South Texas Project Electric Generating Station P.O. Box 289 Wadsworth, Texas 77483

U7-C-STP-NRC-100078

South Texas Project
Units 3 and 4
Docket No. PROJ0772
Response to Request for Additional Information

RAI 23, Figure 1 Block schedule of the SAFIR-BISON interface for the pump model

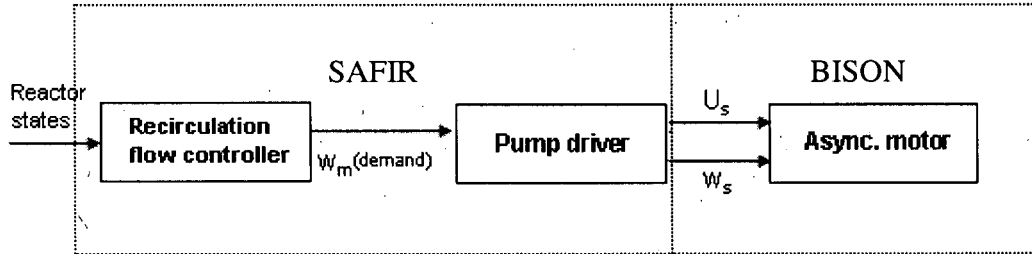
Section 3.8 Table 3-1 of WCAP-17079-P indicates that the recirculation pump speeds are output by SAFIR as well as by BISON (i.e., it is listed as both an input to and an output from BISON).

- a) Explain how ABWR reactor internal recirculation pumps are modeled in BISON-SAFIR, including how the pump speeds can be both an input to and an output from BISON, as described in Table 3-1 of WCAP-17079-P.
- b) Provide a qualification analysis, uncertainty analysis, and range of validity demonstrating applicability of the BISON-SAFIR model of the ABWR reactor internal recirculation pumps.

- a) The use of SAFIR for controlling the recirculation pumps does not change the BISON recirculation pump model approved by the NRC and described in RPA 90-90-P-A. The SAFIR code determines the pump speed demand (W_m) by using various plant parameters, which is then transferred to a pump driver that feeds the BISON asynchronous motor model with a frequency (U_s) and a voltage (W_s) as shown in Figure 1 below. The asynchronous motor uses this information to calculate a pump speed which is the input to the BISON recirculation pump model. The BISON code calculates the pump head and pump torque given the pump speed, in accordance with methods as described in RPA 90-90-P-A. Since SAFIR can be used to control the recirculation pumps, the pump speed can be both an input and an output to the model if the pumps are in speed control mode. If the pumps are in speed control mode, the pump controller uses the current pump speed to calculate the error in pump speed (pump demand minus the current pump speed) to determine the means to maintain a constant pump speed.

Moreover, the recirculation core flow is one of the user inputs to BISON to solve the BISON steady state. When the steady state is solved, BISON determines a pump speed that matches the recirculation core flow and the pump head in accordance to the methods as described in RPA 90-90-P-A. Hence, the BISON determined pump speed can be transferred to SAFIR to initialize models such as Recirculation Flow Controller to a state that corresponds to the calculated steady state pump speed.

- b) The usage of SAFIR for controlling the recirculation pumps does not pose any changes to the BISON recirculation pump model licensed by the NRC as described in RPA 90-90-P-A since the recirculation pumps are not modeled with SAFIR. Therefore SAFIR does not introduce any further uncertainties in the recirculation pump model.

RAI 28, Figure 2 Example of a feedback model

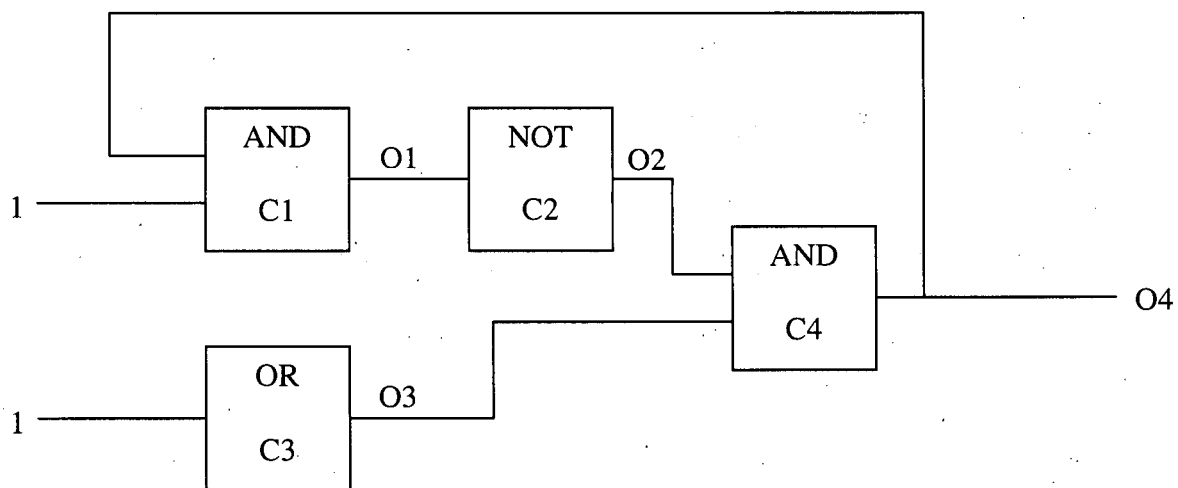
The SAFIR general model description and limitations in WCAP-17079 appear to permit feedback in an input model (i.e., it is possible to construct a closed circular path from an input signal back to itself entirely within SAFIR). Does the SAFIR model used for ABWR contain any such closed loops? If so, describe how a SAFIR solution is obtained for a sampling time interval, given the existence of such feedback loops, and justify its correctness. (For example, consider the hypothetical situation where output from SAFIR component "A" is an input to component "B", and the output from "B" feeds back into "A". If this were simply evaluated once in either order, the outputs of "A" and "B" may be inconsistent since one output changes after the other has been evaluated.) (e.g., does SAFIR iterate within one sampling time interval until a stable solution is obtained for all components? Does it simply evaluate each component once in some fixed order regardless of the existence of feedback loops, resulting in a possibly inconsistent solution?)

SAFIR permits feedback such as constructing a closed circular loop from an input signal back to itself. This feature can be used in many applications such as in controllers to feed back the output signal to the input signal. Figure 6-90 in Supplement 3 is an example on a model where such feedback is used in the SAFIR model for the ABWR.

SAFIR uses an explicit calculation scheme and does not iterate to get a stable solution except for the steady state iteration. Instead, the user supplied order of the components matters. The component that is first in order is evaluated first and then the second component and so on. Note that the component will only be updated if its sample time permits it.

An illustrative example is provided in Figure 1 below for a feedback loop. The components are supplied in the order of C1, C2, C3 and C4 and the outputs are named O1, O2, O3 and O4. The output (O4) from component C4 is feed back to component C1 and is assumed to be initialized to 1 for the steady state iteration. Furthermore, the components are assumed to have the same sampling time. The output signal O4 for each time step is shown in Table 1. As can be seen in the table, the output signal is assigned the values 0 and 1 every second time step. Note that if an iterative solution technique is used, the output signal would never converge despite the fact that the model as shown below is a valid one.
